**PLANNING APPROVAL &
SUBDIVISION STAFF REPORT****Date: February 19, 2009**

| <u>SUBDIVISION NAME</u> | Government Street Development Subdivision |
| <u>LOCATION</u> | 1007 Government Street (Southeast corner of Government Street and Chatham Street, extending to the North side of Church Street, 100'± East of Chatham Street) |

SITE PLAN

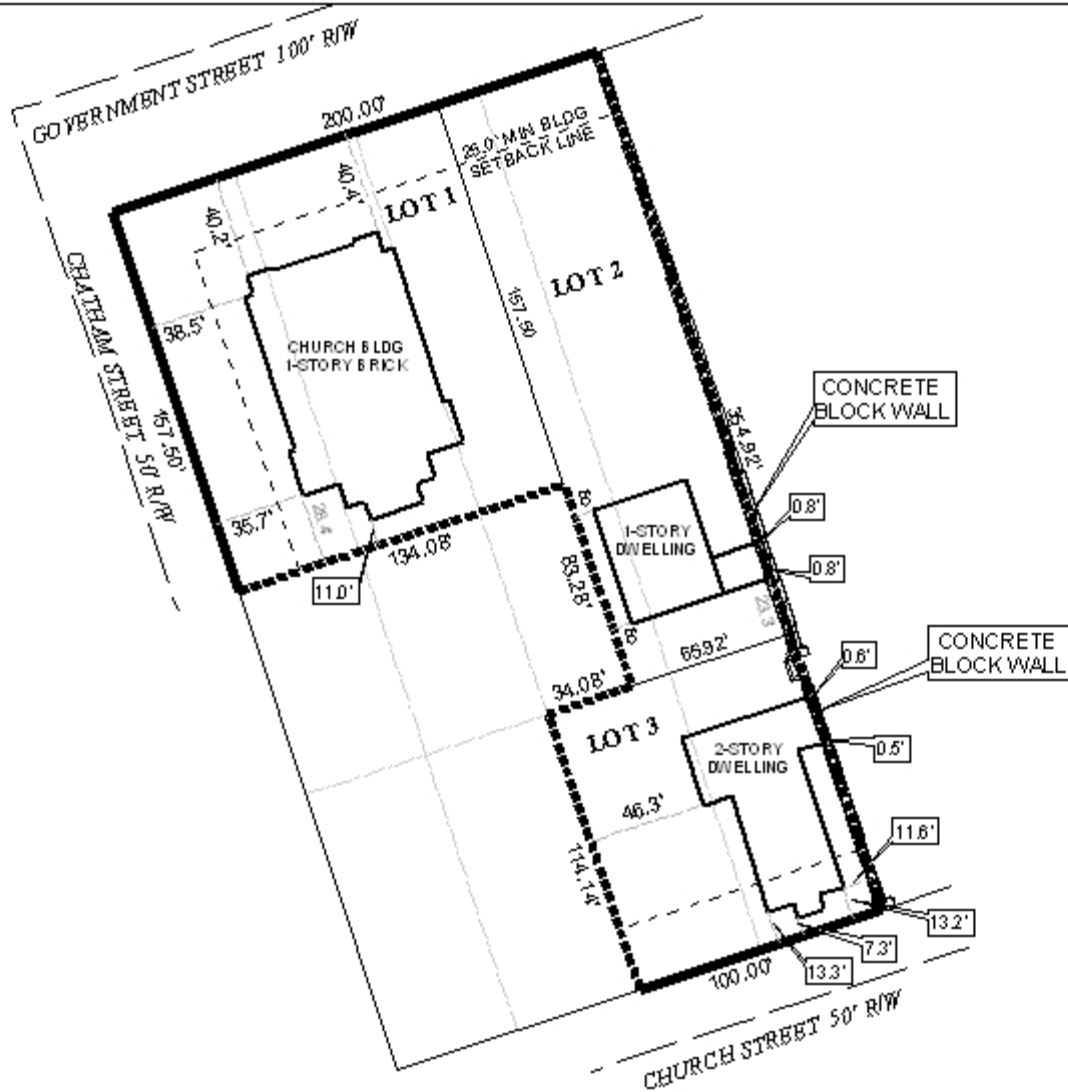
No information was provided regarding the existing church. Parking for churches is based upon 1 parking space per 4 pew seats, however, the site plan depicts no improvements and, in fact, the site has no paved parking. Parking occurs in the grassy area of proposed lots 1 and 2, and buses are stored on grass next to the existing structure on proposed lot 3. Typically the Planning Commission requires site improvements for churches located in residential areas, thus the application should be revised to show the site improved in accordance to the requirements of the Zoning Ordinance, or indicate where applications to the Board of Adjustments will be made for variances.

The Planning Approval site plan should also specifically indicate which lots are to be included within the approval. If multiple lots, shared parking, multiple buildings, etc. are included, then an application for Planned Unit Development will also be required.

It should also be pointed out that the Subdivision plat should depict existing curb-cuts, if the applicant wishes to request that they remain.

Finally, information regarding the size of the lots in square feet has not been provided.

- 1) Revision of the site plan to depict full compliance with the requirements of the Zoning Ordinance regarding site improvements for the church, and/or depiction of variances that will be requested via the Board of Adjustment;
- 2) Depiction and labeling of existing curb-cuts that the applicant requests to remain; and
- 3) Revision of the site plan to clearly show which properties are included with the Planning Approval, and submission of an application for Planned Unit Development, if necessary for shared parking, multiple buildings, etc.

- 1) Revision of the plat to include parcel R022906390004070.001. or provision of documentation justifying its exclusion from the application;
- 2) Provision of additional labels, postage and lot fees regarding the item in condition # 1, if an additional lot must be created;
- 3) Depiction and labeling of existing curb-cuts that the applicant requests to remain; and
- 4) Labeling of the lots with their size in square feet.
